DESCRIPTIVE REPORT

Type of Survey ..Hydrographic.....
Field No.RA-10-1-85.....
Registry No.H-10176.....

StateAlaska.....
General Locality ..Seymour Canal.....
SublocalityMole Harbor to Pleasant Bay.....

HYDROGRAPHIC TITLE SHEET

DAVIDSON RECONNAISSANCE SURVEY

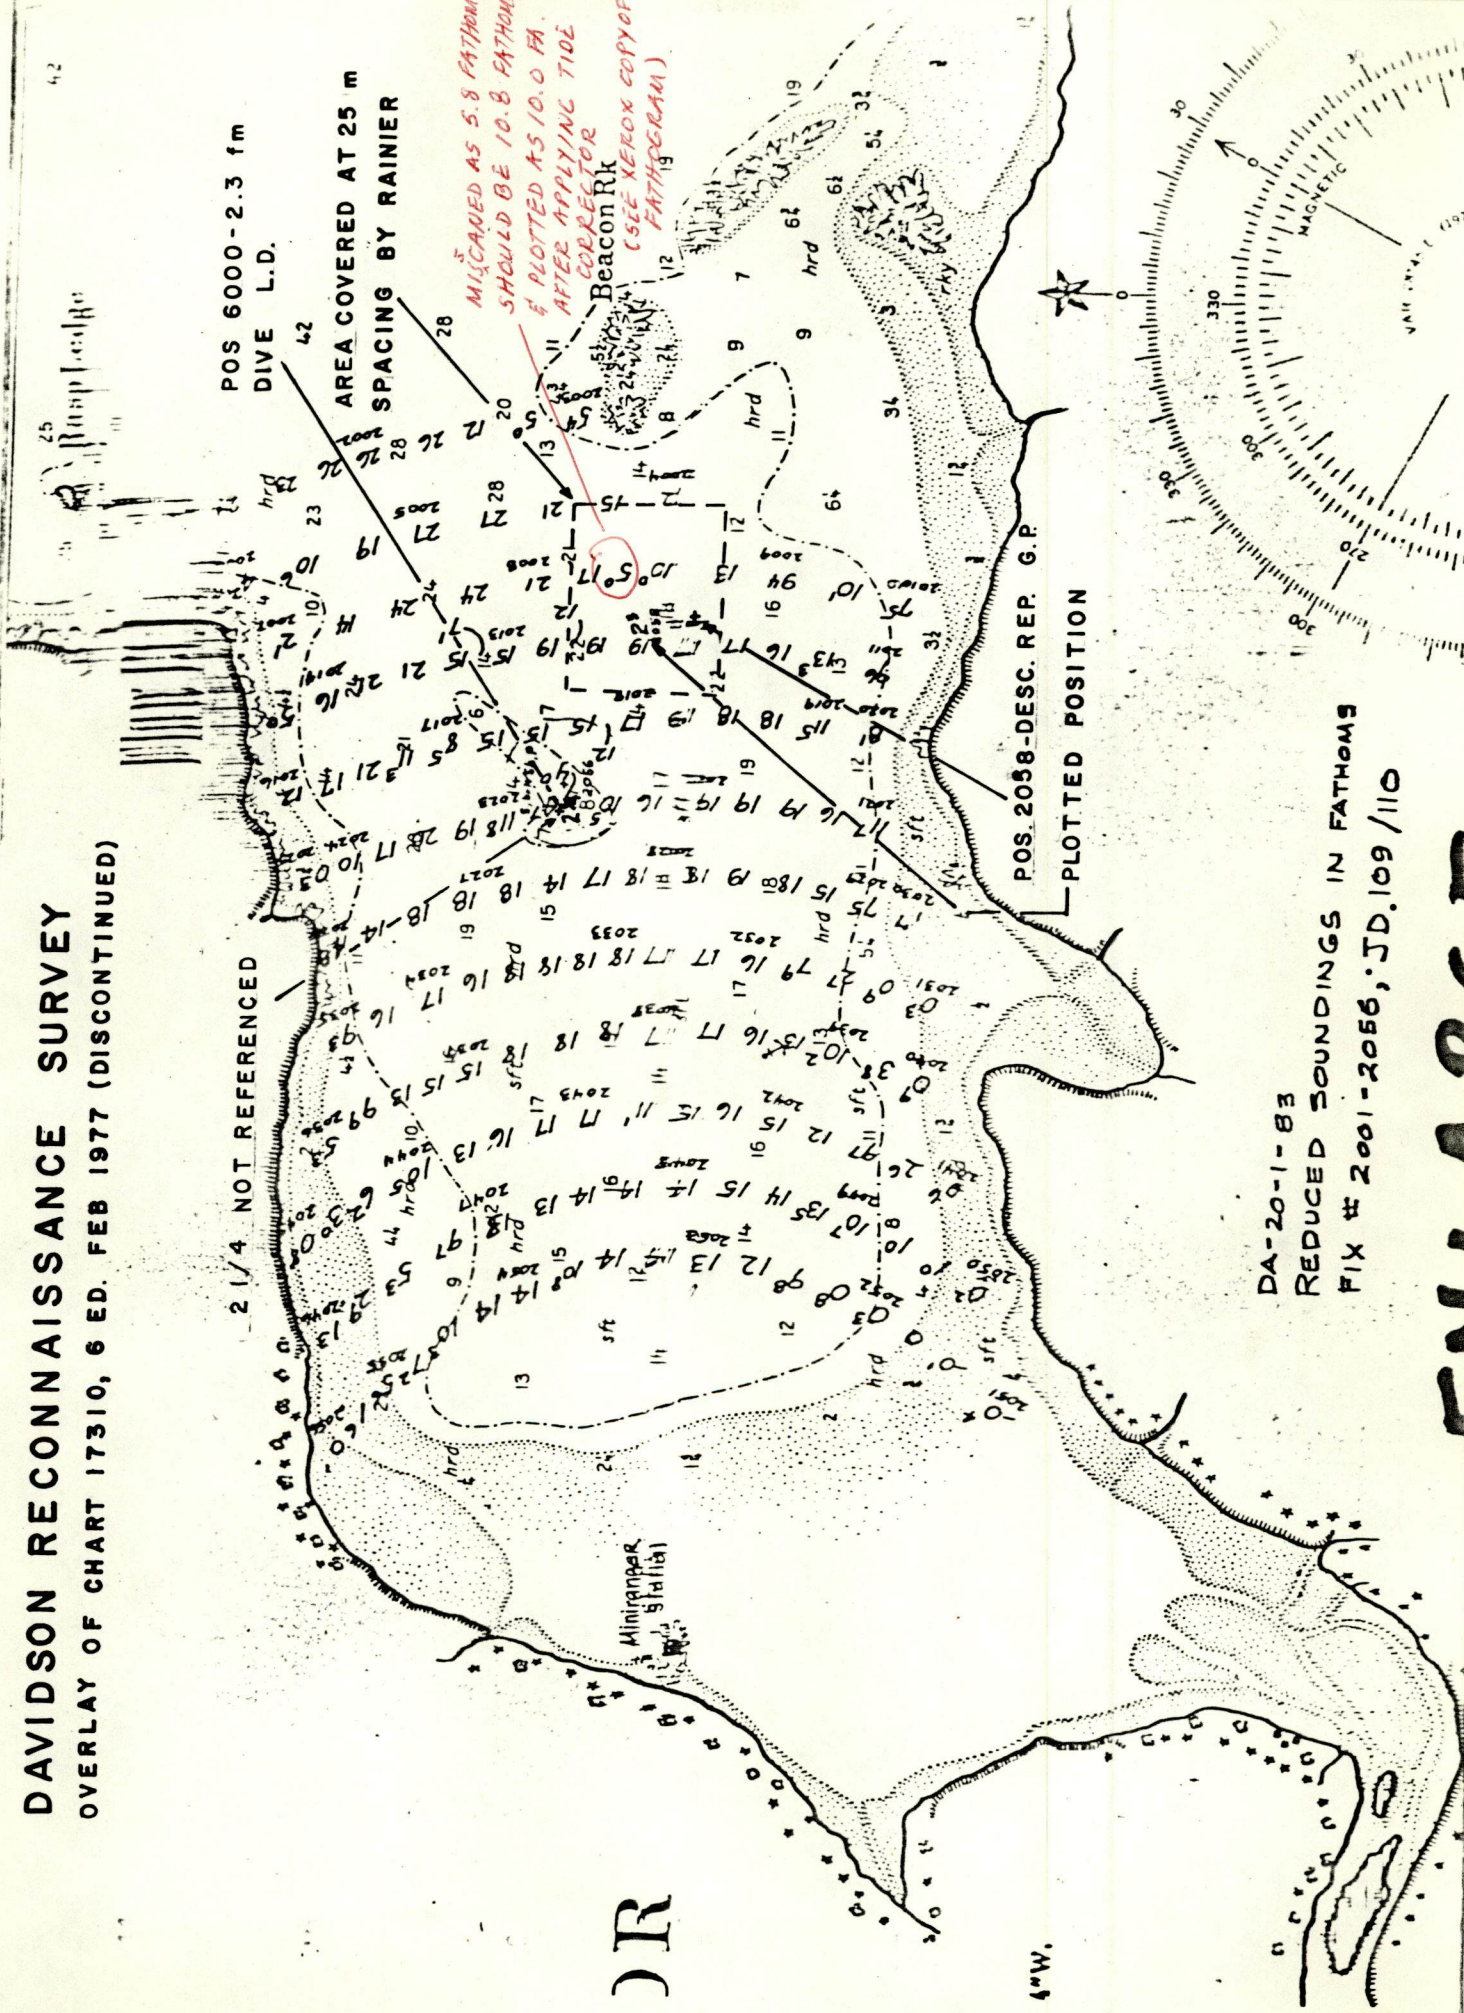
A separate 2 1/4 fm DAVIDSON depth is shown near RAINIER position 6000 approximately 500 m NW of position 2058. No reference to this depth is made in the descriptive report.

5. MI-CALCULATED AS 5.8 FATHOMS
SHOULD BE 10.8 FATHOMS
4. PLOTTED AS 10.0 FA.
AFTER APPLYING TIDE
CORRECTOR
Beacon Rk
(SEE XEROX COPY OF
FATHOMGRAM)

21/4 NOT REFERENCED

POS. 2058-DESC. REP. G.P.

The 2 1/4-fathom depth, shown near RAINIER position 6000 approximately 500 meters northwest of DAVIDSON position 2058, is shown on the DAVIDSON field sheet in pencil and originated subsequent to the submission of the DAVIDSON reconnaissance survey, thereby explaining the lack of reference to this depth in that survey's records.

The situation is further complicated by a 5-fathom sounding on the DAVIDSON survey located approximately 200 meters east of the questioned 2.3 fathom depth and an 8.7-fathom shoal on H-10176 in proximity of that same position, indicating the existence of a shoal in this area. A check of the survey records, however, indicates that the 5-fathom sounding is misscanned by 5 fathoms and is actually a 10-fathom sounding (see attached echogram copy).

RECOMMENDATION: Chart the 2.⁴/₅ fathom shoal based on the current survey position 6000.

concur

S-0902-DA-83
DAVIDSON RECONNAISSANCE SURVEY
DA-20-1-83

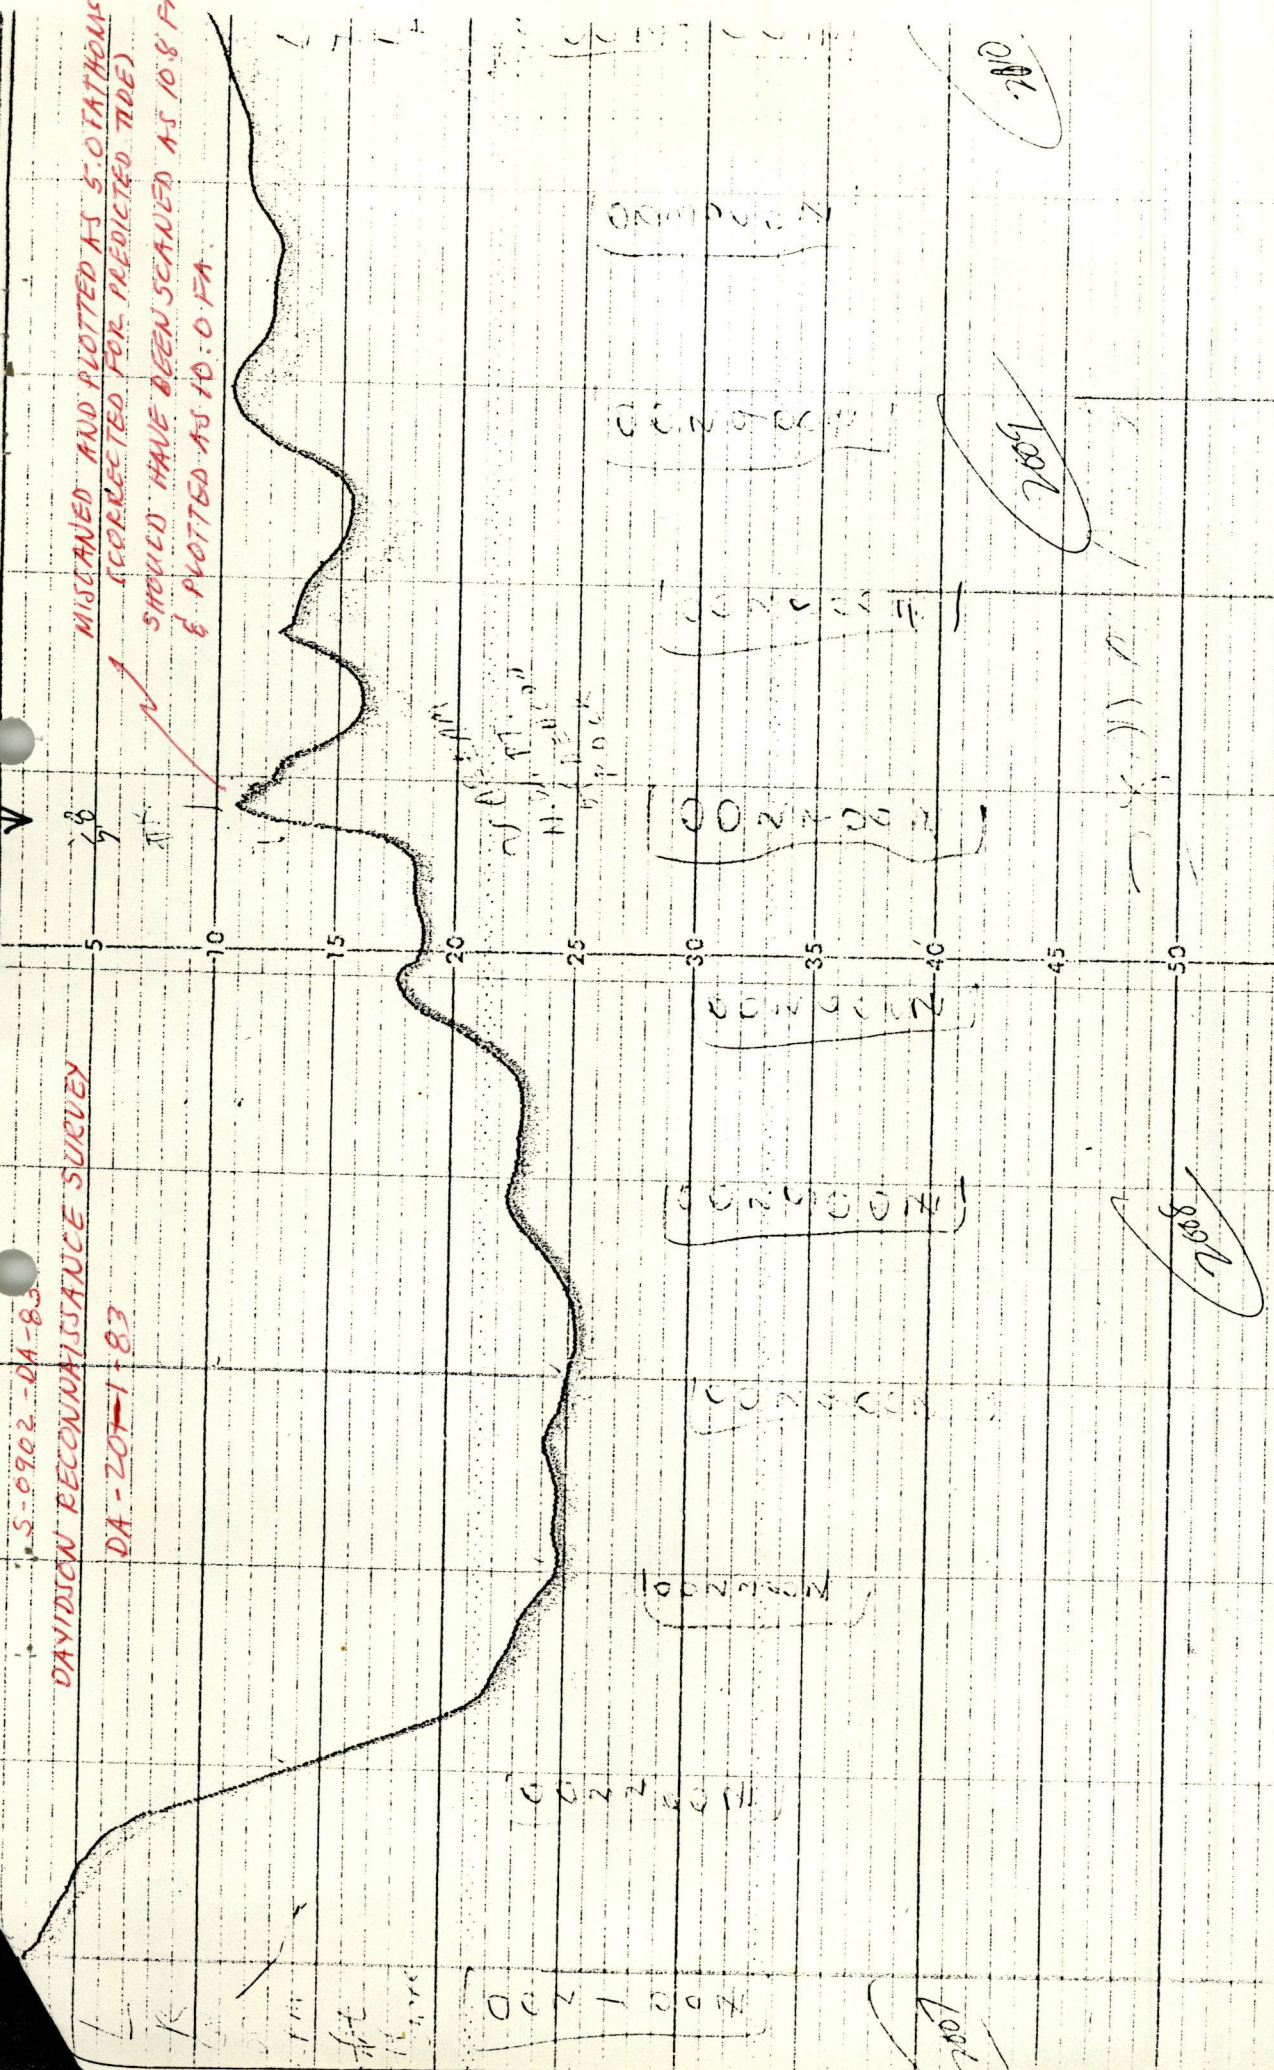
MISSED AND PLOTTED AS 5.0 TATONS.
CORRECTED FOR PREDICTED TIDE
SHOULD HAVE BEEN SCANNED AS 10.8 FA
& PLOTTED AS 10.0 FA.
